SERVICE BULLETIN
REVISION TRANSMITTAL SHEET

MODIFICATION NO: 23326K3041

TITLE: AIR CONDITIONING - PRIMARY INSULATION - IMPROVE INSULATION BETWEEN THE EMERGENCY EXIT DOORS

SERVICE BULLETIN NO: A320-21-1063

Replacement of Insulation Blankets Between Emergency Exit Doors Figure 1

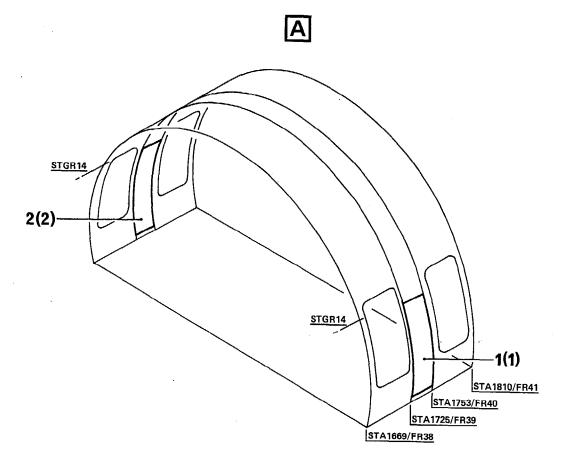
(1) Replace the primary insulation between the emergency exit doors.

Refer to Figure 1

- (a) Between FR39 and FR40, remove and discard the insulation blankets items (1) and (2), (Ref. AMM 25-80-00, P. Block 401).
- (b) Between FR39 and FR40, install the insulation blankets.

D2587040600400, item 1 (LH) D2587050600400, item 2 (RH)
